IOWA DEPARTMENT OF TRANSPORTATION

TO OFFICE: District 3
DATE: July 19, 2012
ATTENTION: Tony Lazarowicz
REF. : Woodbury County
NHSX-020-1(121)--3H-97
FROM: Yanxiao Jia
PIN: 98-97-020-010-02
OFFICE: Design
STP-031-1(32)--2C-97
PIN: 98-97-020-010-03
SUBJECT: Field Exam – City of Correctionville

A field exam was held on June 21, 2012 to review the proposed plan for the reconstruction of U.S. 20 and relocated IA 31 in the City of Correctionville.

Field Exam Plans

Relocated
 Mainline
 IA 31

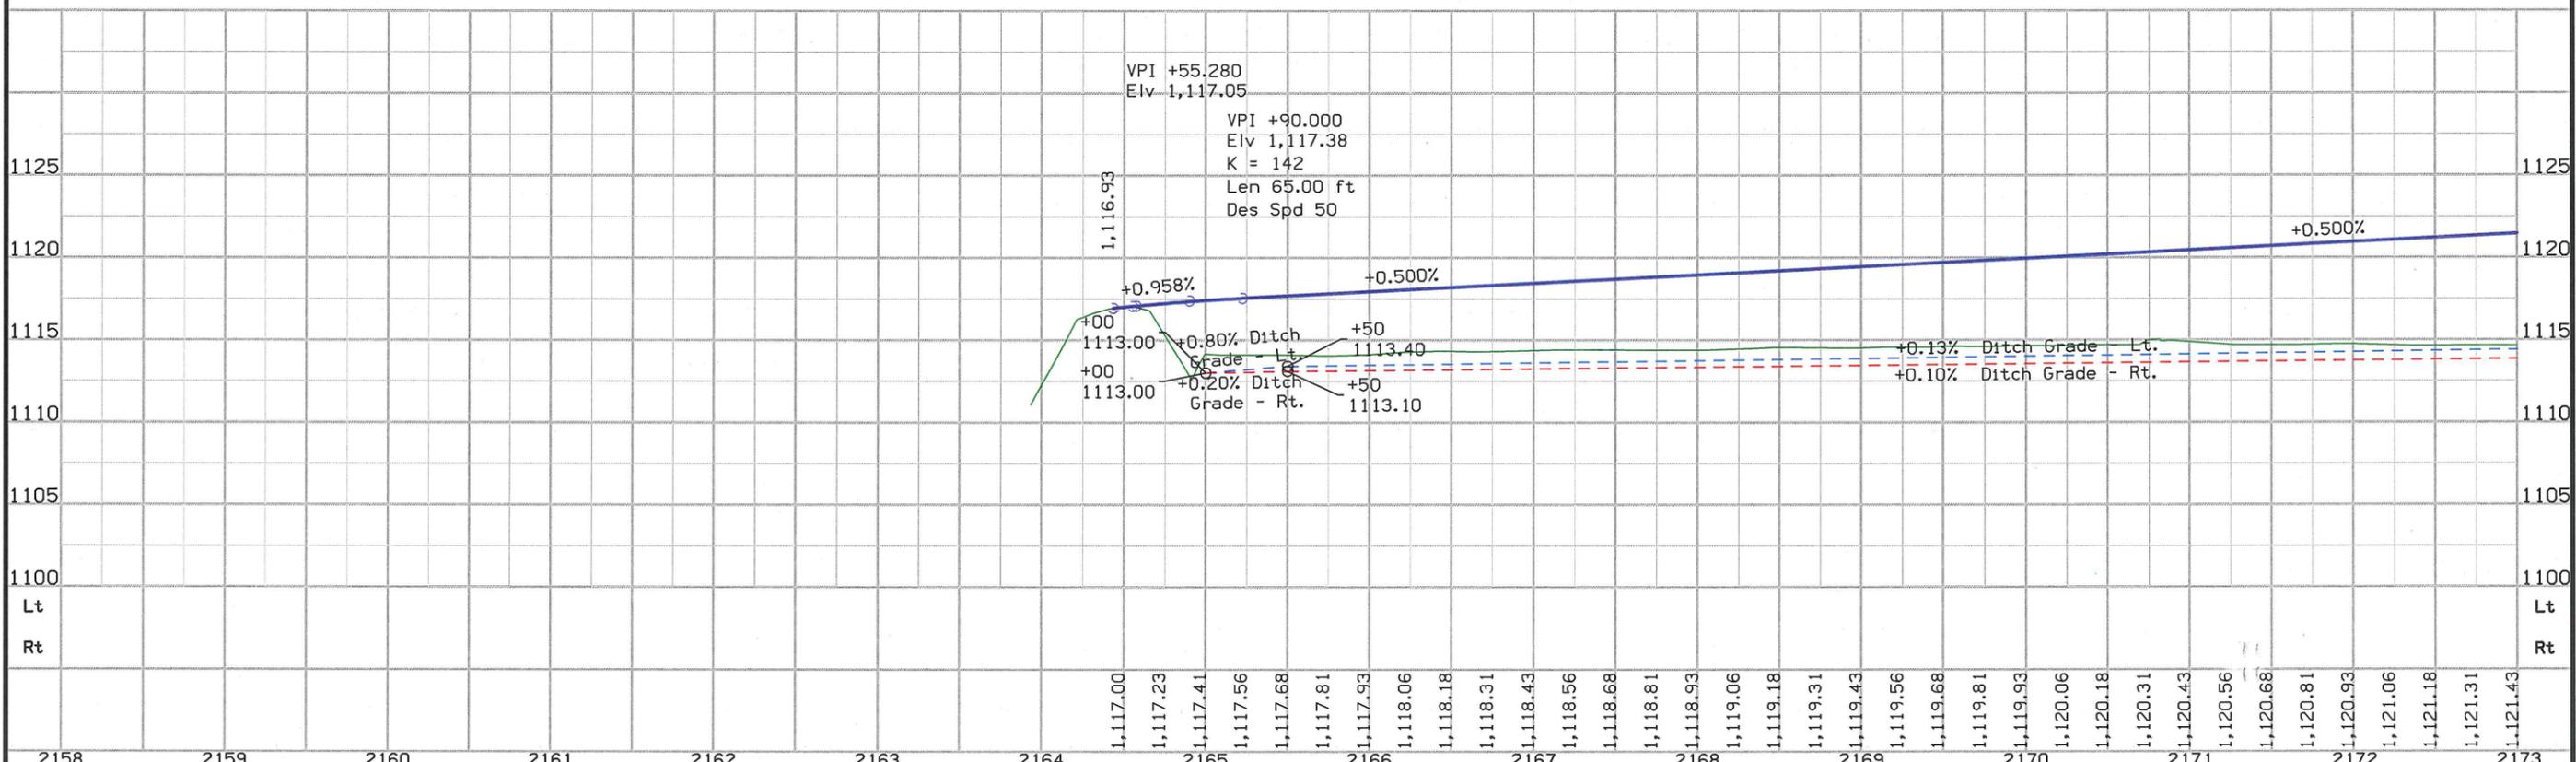
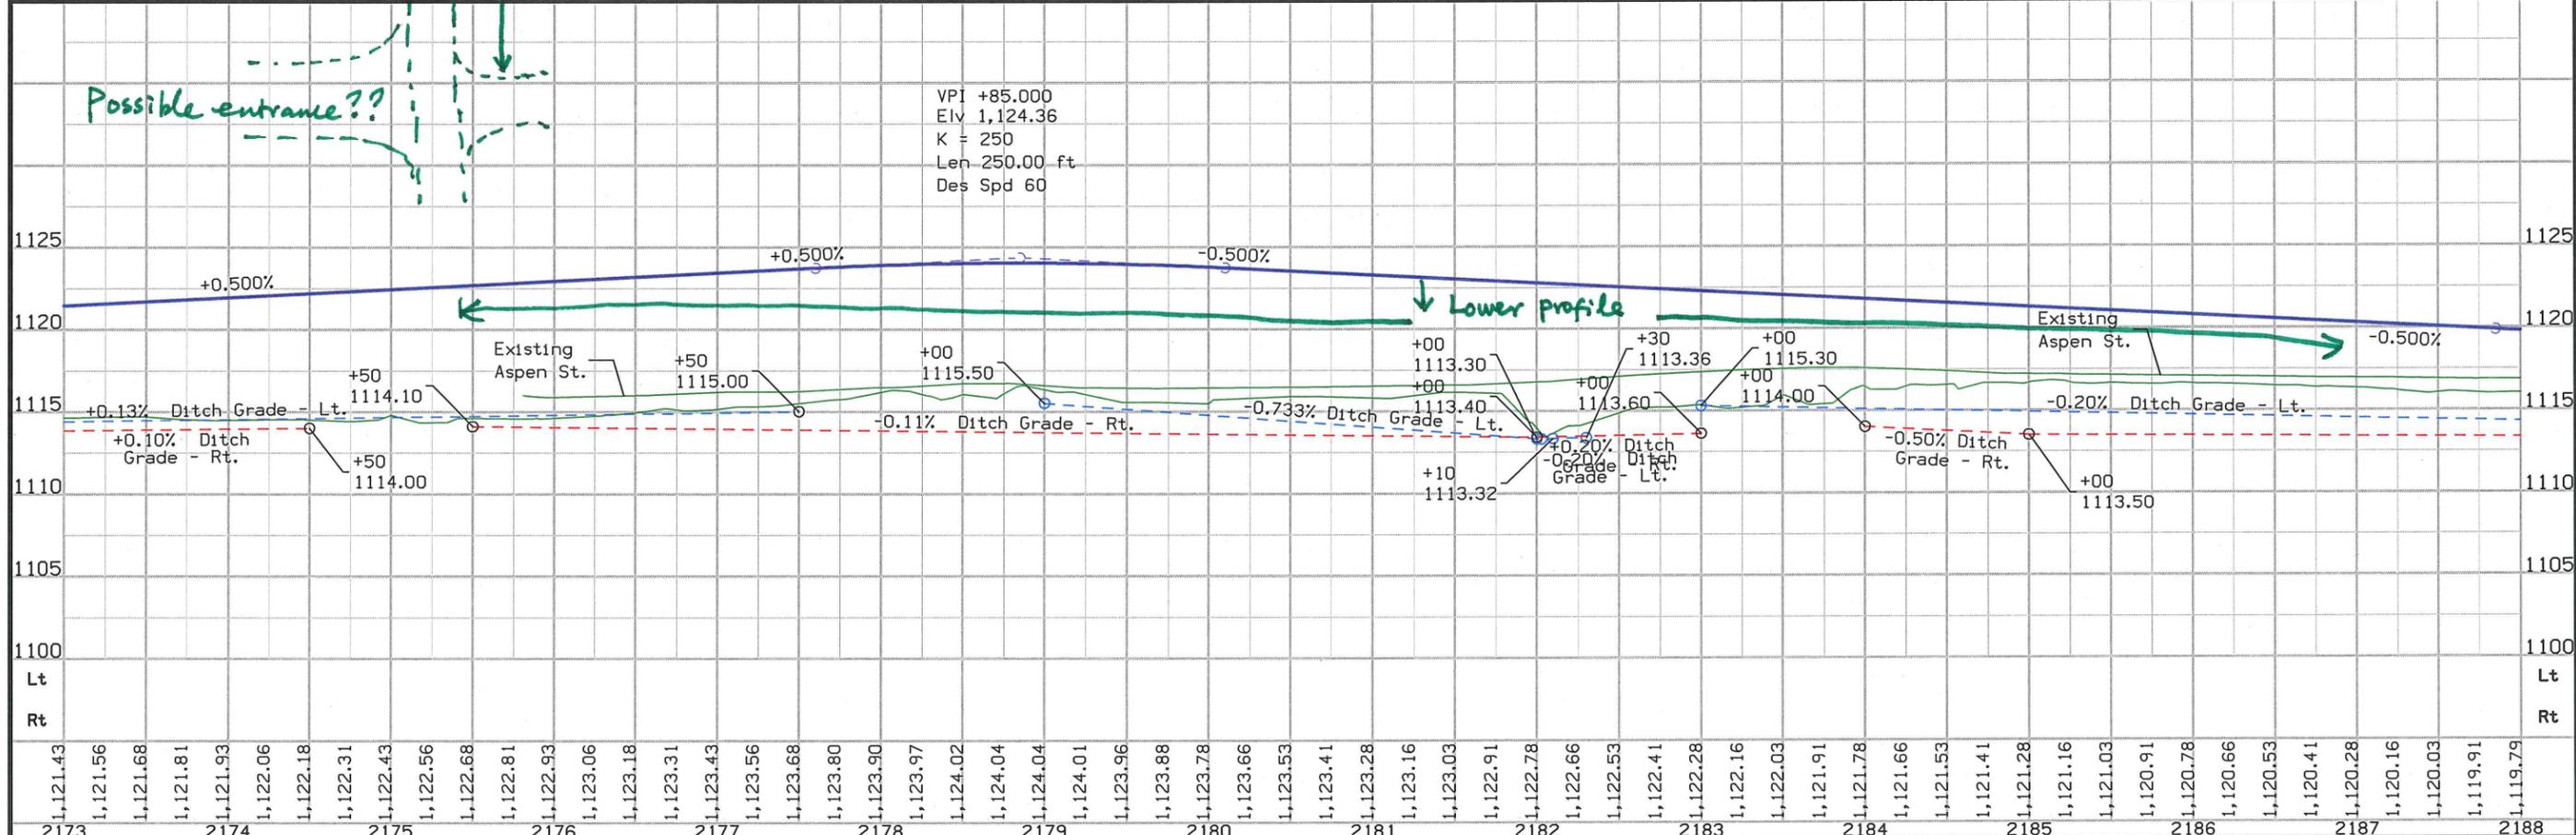
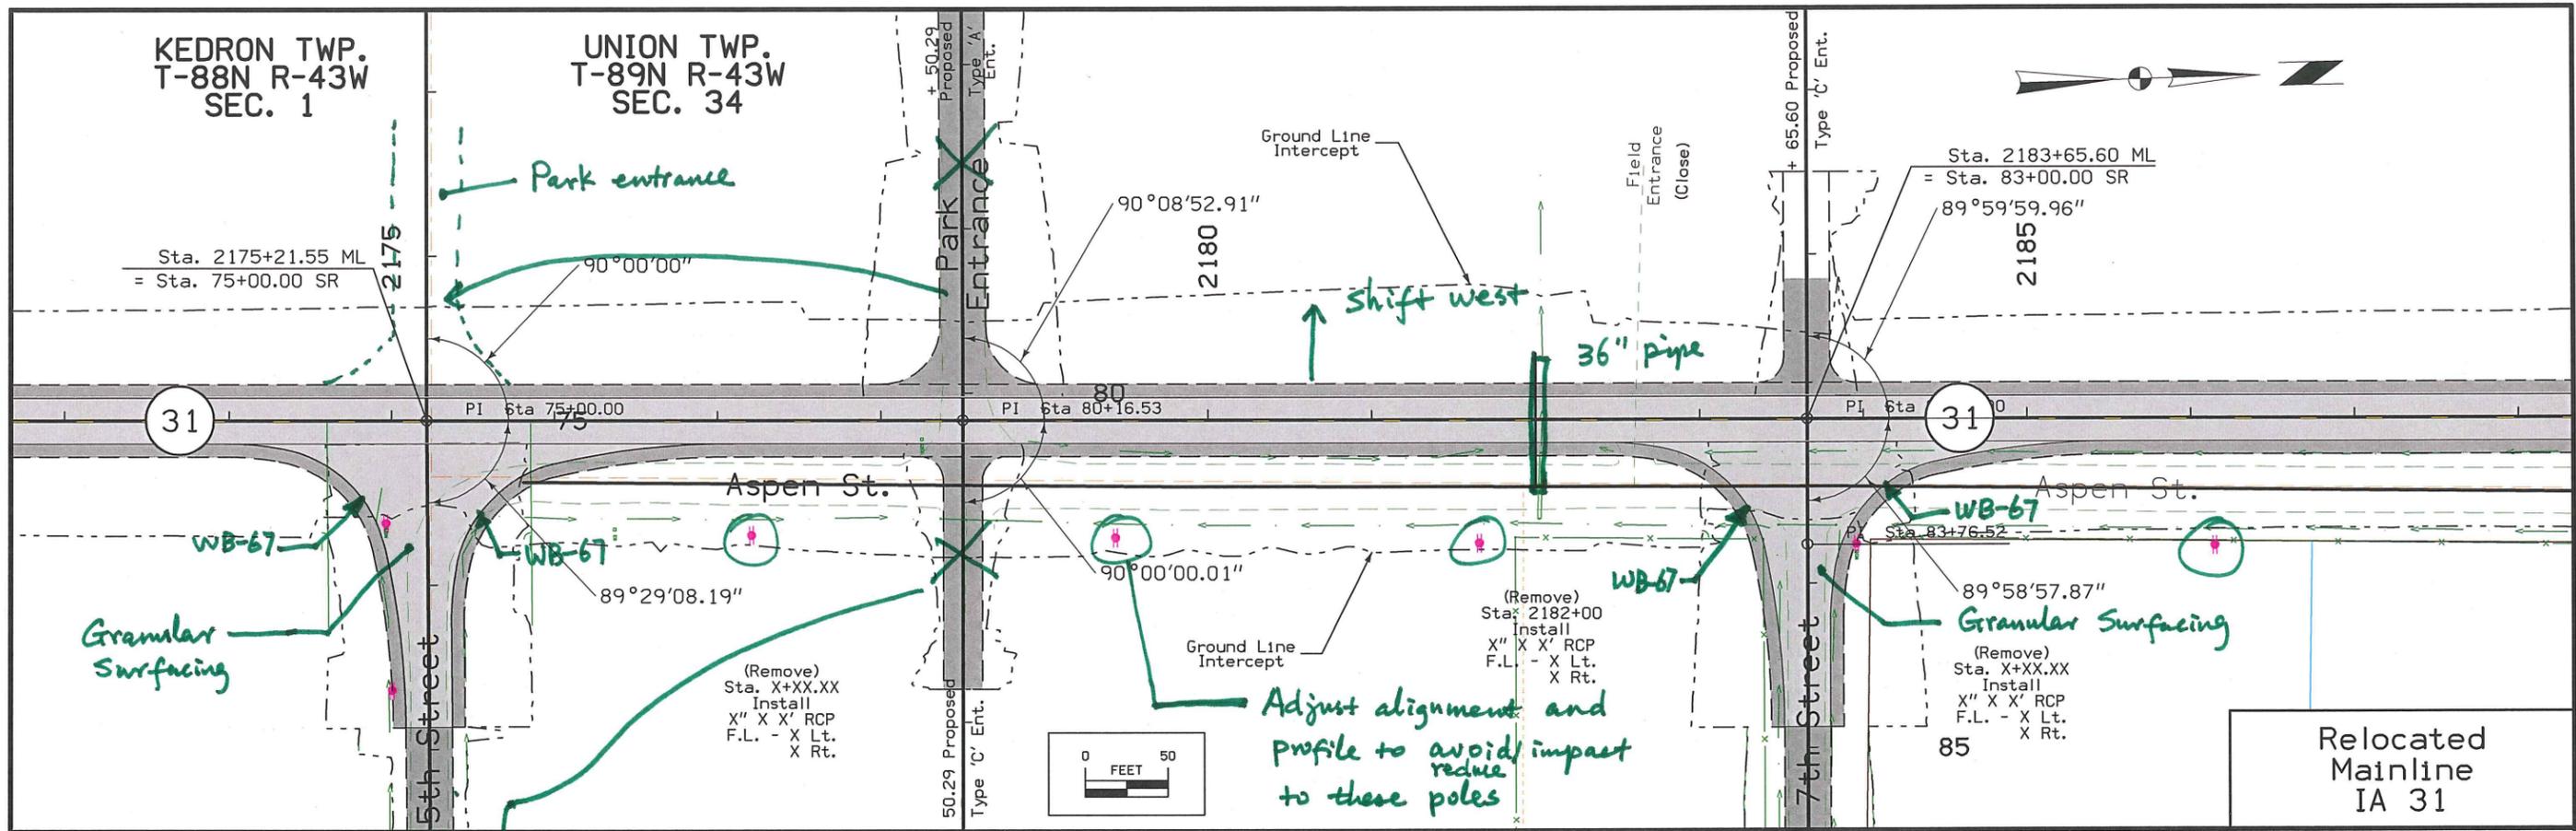
Install rumble strip
Review w/ Traffic and Safety
